Project Erebus: Further Clarifications

- 1.1.1.1 This report has been produced in response to Natural Resources Wales (NRW) Marine Licensing's email dated 17 November 2022, requesting clarifications and amendments under the Marine Works (Environmental Impact Assessment) Regulations 2007 (as amended) for Marine Licence application ORML2170 Project Erebus. The Project is a demonstration scale Floating Offshore Wind (FLOW) development in the Celtic Sea region, proposed by the developer, Blue Gem Wind (BGW), a joint venture between Simply Blue Energy (SBE) and TotalEnergies.

Figure 2-1: Proposed location of predicted areas of cable protection (purple) in the vicinity of Turbot Bank

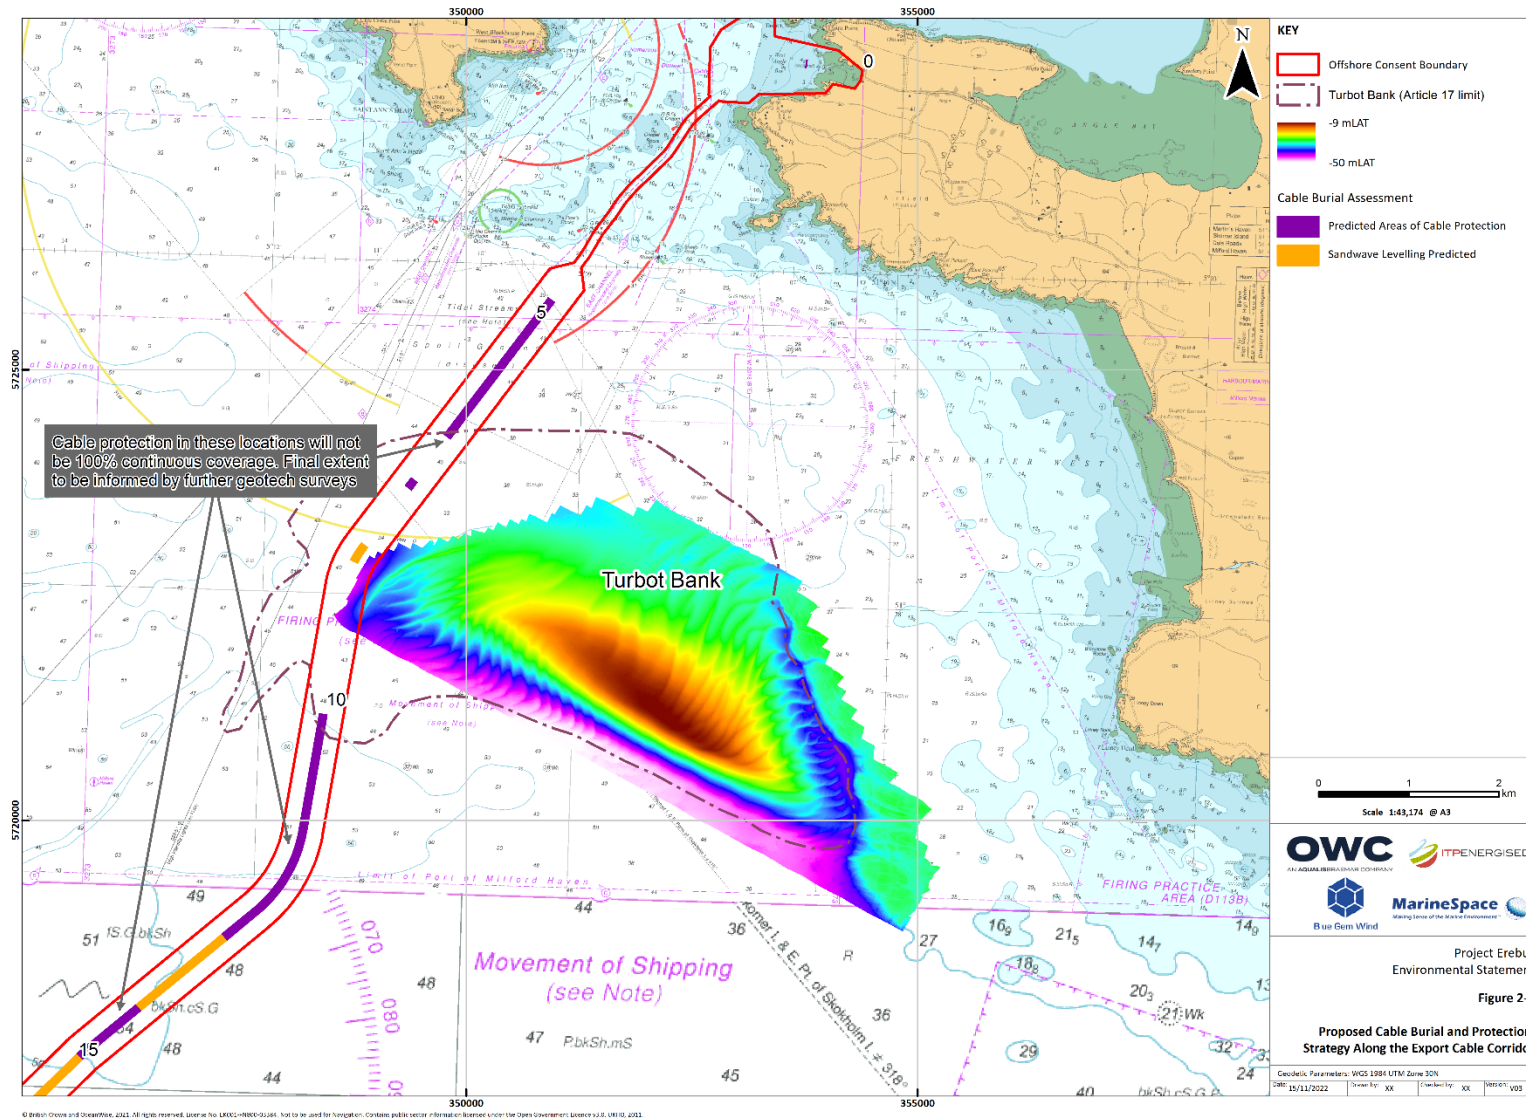
- 2.2.1.2 Notwithstanding the above, localised sections of external cable protection are predicted to be required, and especially in the vicinity of Turbot Bank. The proposed locations of the predicted areas of external berm cable protection are shown in Figure 2-1 and an overview of ongoing engineering studies is provided below in Section 2.3.

- 2.2.1.3 Importantly, Figure 2-1 shows that the external cable protection will not be continuous along the route. Moreover, even in those areas where the potential for cable protection is highlighted, coverage will not be 100% with the final extent being informed by further geotechnical surveys. The latest iteration of the ongoing cable protection engineering design work also suggests that there is potential for reducing the actual height of the cable protection rock berm from 'up to 2.0 m', to 'up to 1.5 m' for those sections of cable protection to the north and south of Turbot Bank. Further information is presented in Section 2.7.

- Shipping and Fishing anchor and chain drag protection.
- 2.7.1.6 On the basis of the additional engineering study (OWC⁶) the Applicant has now committed to a maximum berm height of 1.5 m for the lengths of cable protection to the north and south of Turbot Bank.

Figure 2-2: Predicted patterns of long-term sediment transport pathways in nearshore areas and detail around Turbot Bank

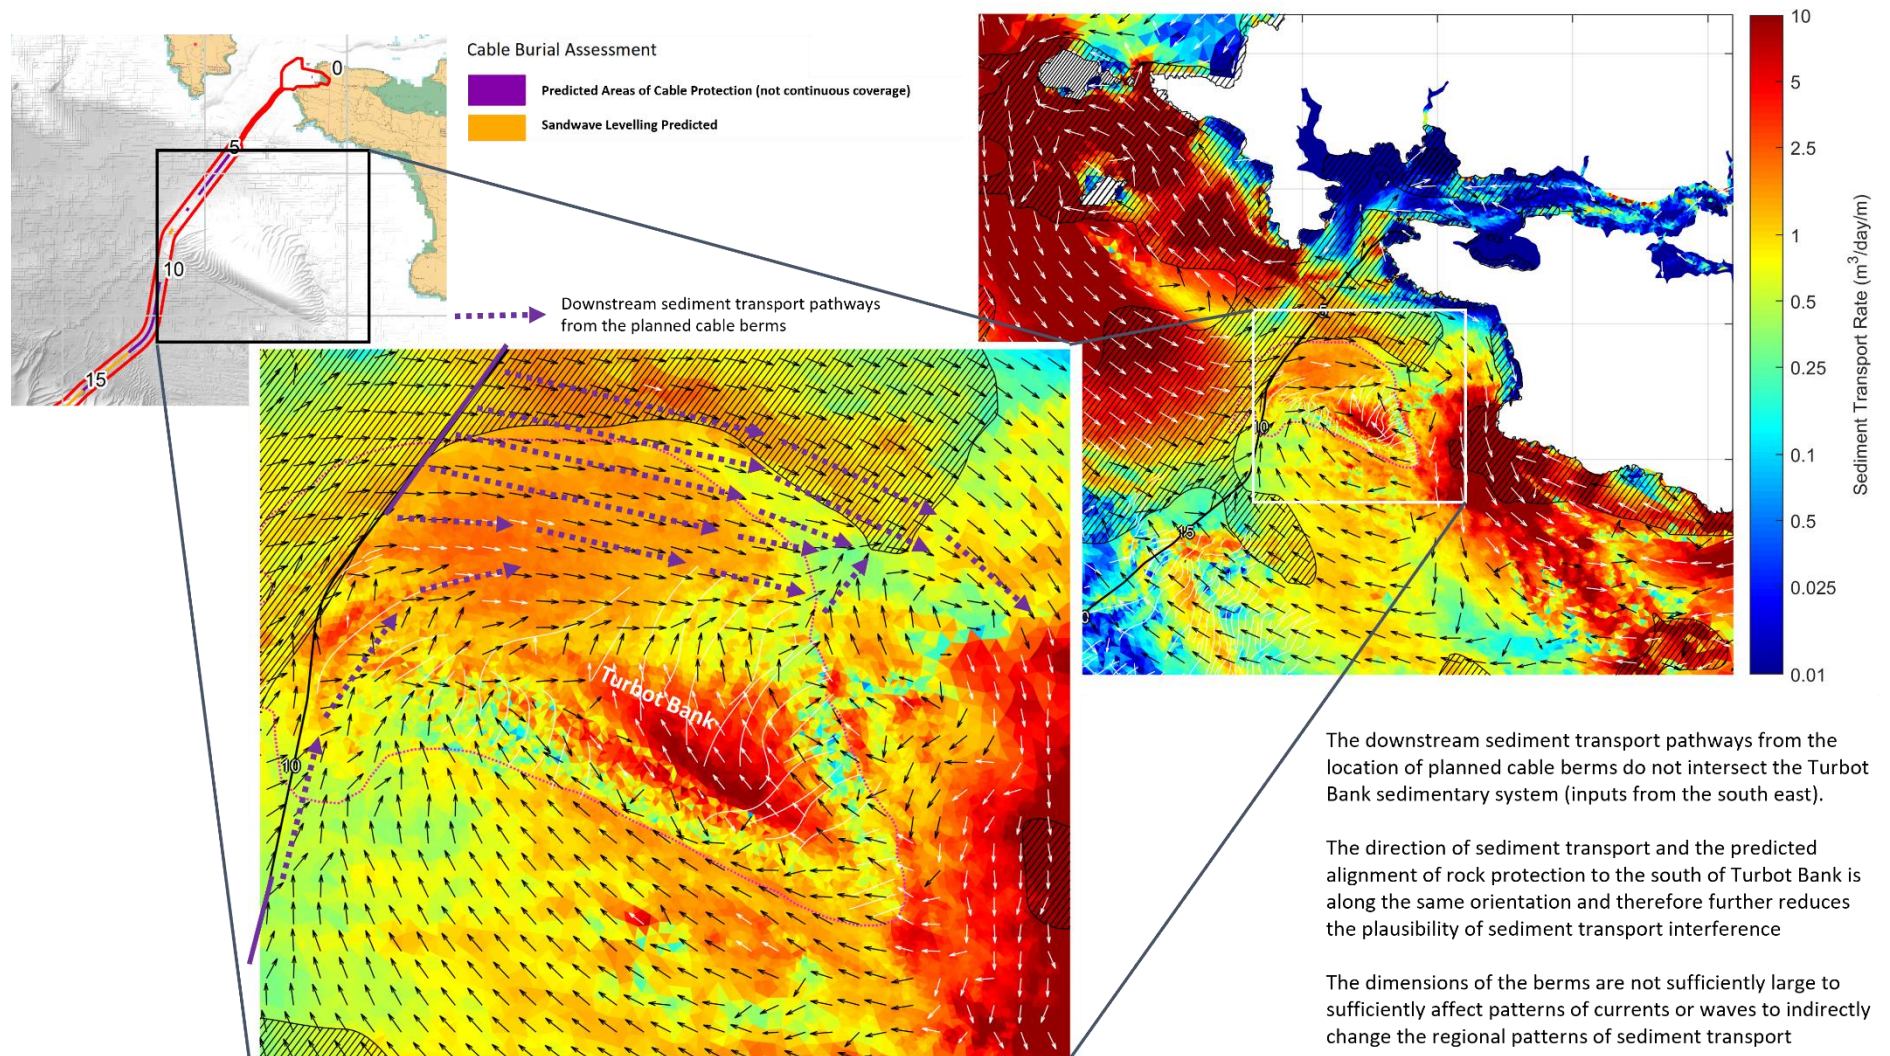
- 2.5.3.1 NRW Advisory comment: *“The assessment (based on expert judgement) notes that the external cable protection rock berms fundamentally have little to no potential to block or otherwise change the magnitude or direction of long-term sediment transport locally, or regionally elsewhere, indirectly through changes to patterns of currents or waves. Even though this could potentially be the case, there is a degree of uncertainty in the assessment due to remaining uncertainty in the details of the final impact description that relate to the baseline understanding of sand wave migration rates on Turbot Bank (ideally requiring additional historical survey data, which do not exist, to the applicant’s knowledge) and the finer detail of sediment transport pathways and linkages in the wider area (presently supported by regional tidally driven sediment transport modelling) which is a tide only model and does not include the contribution of waves.”*

- An illustration of the assessed (numerically modelled and interpreted) sediment transport regime is provided as Figure 2-2. This shows that downstream sediment transport pathways from the proposed areas of cable protection do not intersect directly with Turbot Bank. As such, even if a measurable effect were to occur (which is considered unlikely), then there is no identified pathway for the effect to extend from the berm to Turbot Bank. As the pathways have been mapped using a number of complimentary evidence sources (including detailed numerical sediment transport modelling validated using high-resolution bathymetry data of the bank), **the Applicant submits that there is high confidence in the conclusion that downstream sediment transport pathways do not intersect directly with Turbot Bank**

- 2.5.3.5 A detailed description of physical processes both within the Project Red Line Boundary and across the wider study area has previously been provided in the Erebus ES (Blue Gem Wind, 2019). An illustration of the sediment transport processes using the output from the sediment transport model (including the inferred direction and magnitude of sediment transport) is shown in Figure 2-2. The modelling has been validated to be in good agreement with morphological (bathymetric) evidence of bedform shape and asymmetry, which are reliable proxy indicators for both general mobility and direction of migration⁵.

Figure 2-3: 3D visualisations of Turbot Bank derived from the high resolution multibeam data collected by CCW in 2012. The proposed cable route is shown as a black line.

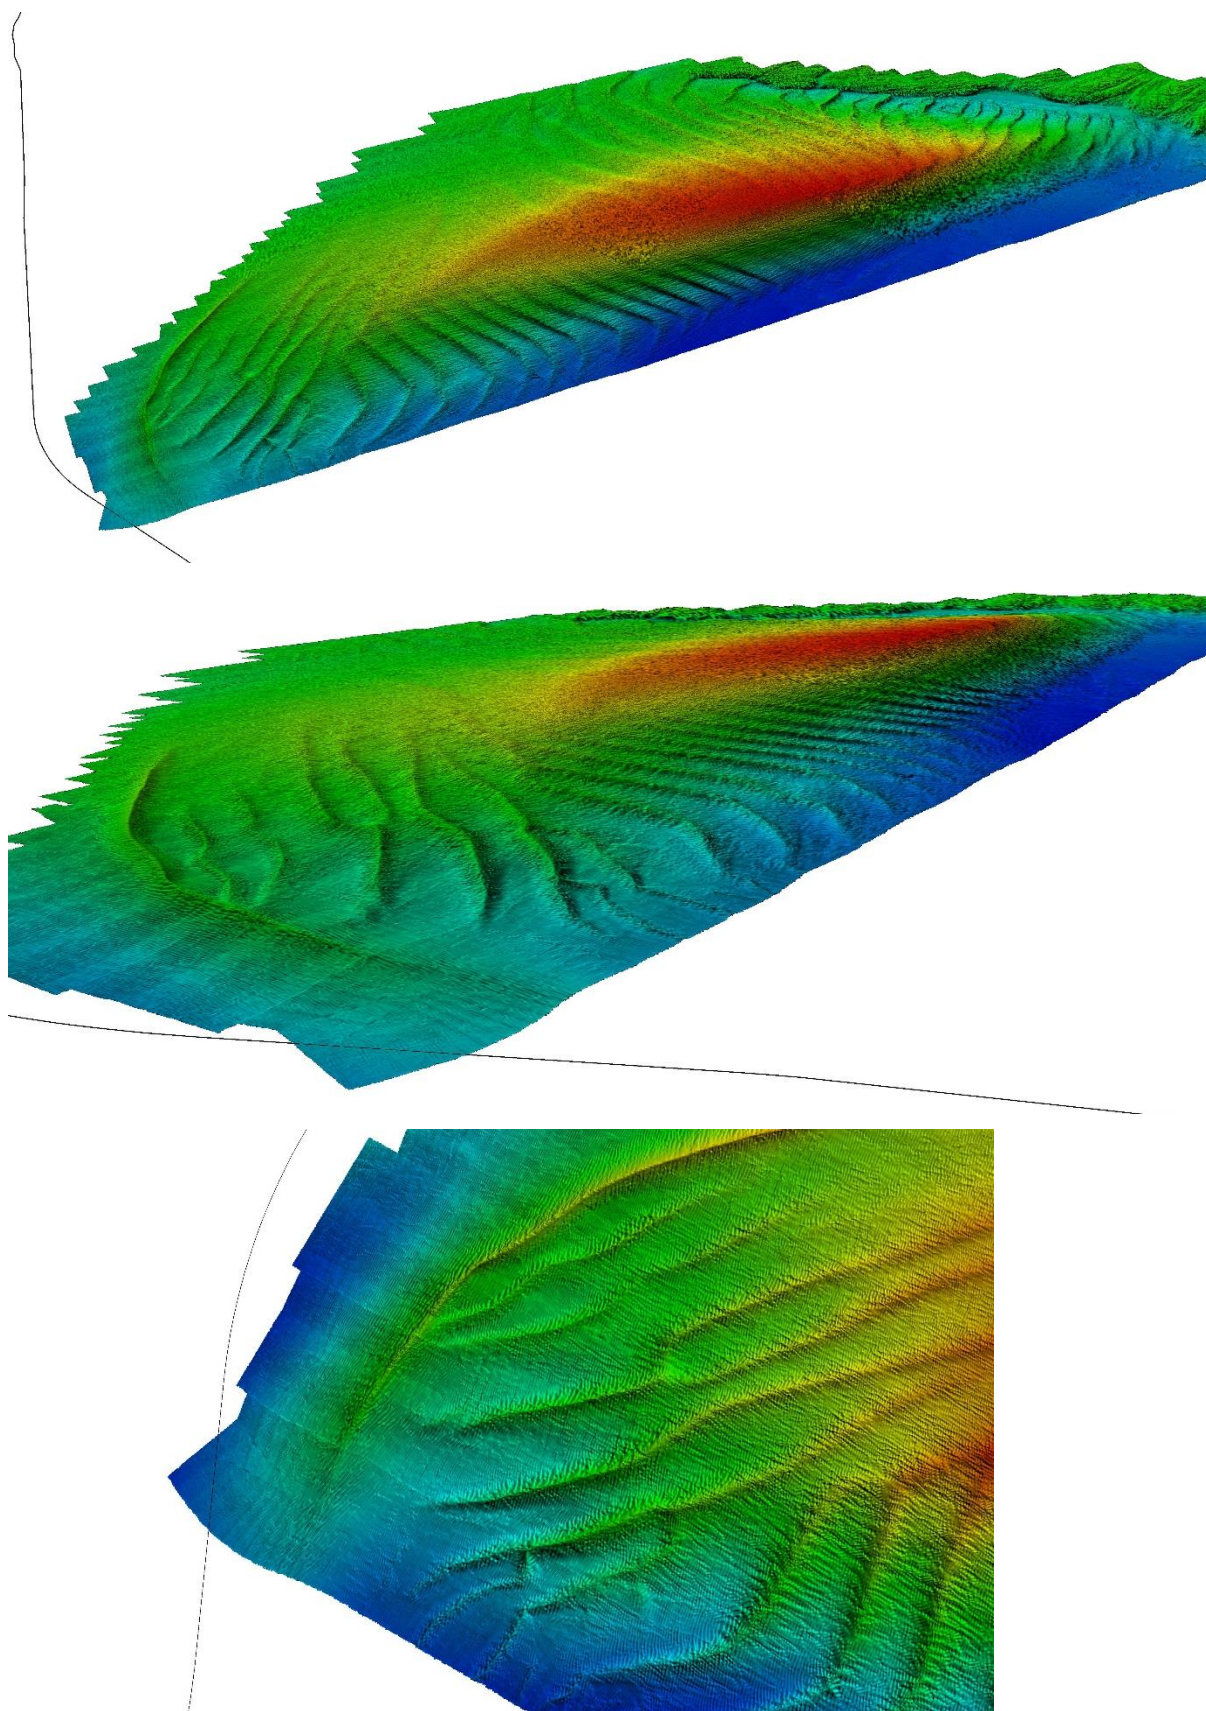
- 2.5.2.1 NRW Advisory Comment "*We acknowledge that the ES assessment provided a reasonable theoretical conclusion on the basis of the evidence available without further survey. We note that in pre-application discussions on the Geophysical Survey specification we did advise the applicant that any large features such as Large and Very Large Subaqueous Dunes should be captured in their entirety to allow an understanding of volume changes and direction of travel. This was not undertaken, if it had been then it would have reduced the uncertainties we have in relation to the baseline understanding of sand wave migration rates on Turbot Bank and the detail of sediment transport pathways and linkages in the wider area that make up the form and function of the Annex 1 sand bank features of Turbot Bank.*"

- 2.5.2.5 To inform the assessments, the project has used high resolution (1 m gridded) multibeam bathymetric survey data (CCW Multibeam survey of Turbot Bank (2012)), which resolves sandwave and smaller megaripple bedform features superimposed on the bank itself (Figure 2-3) to undertake morphological analysis. The extent of the data is understood to encompass nearly the full area of active sediment transport maintaining the bank. The data and analysis corroborate the results of the numerical sediment transport modelling undertaken to support the assessment.

- 2.5.2.6 During the ETG (dated 19 October 2022) NRW Advisory incorrectly assumed the CCW data to be of 'low resolution'. In fact, the CCW data have been collected to a comparable resolution and spatial extent to that requested by NRW.

- 2.5.2.7 **In conclusion, the high-resolution nature of the 2012 CCW Turbot Bank bathymetric data has enabled detailed morphological analysis of the bank to be carried out, enabling robust baseline understanding.** Whilst the lack of bathymetric surveys of Turbot Bank from different epochs precludes quantification of sandwave migration rates in all areas on and around the bank, the conclusions of the Applicant's assessment, do not require, or rely upon, a specific bedform migration rate around Turbot Bank. This is accordingly not a reasonable basis on which to assert that the Applicant's assessment is deficient.
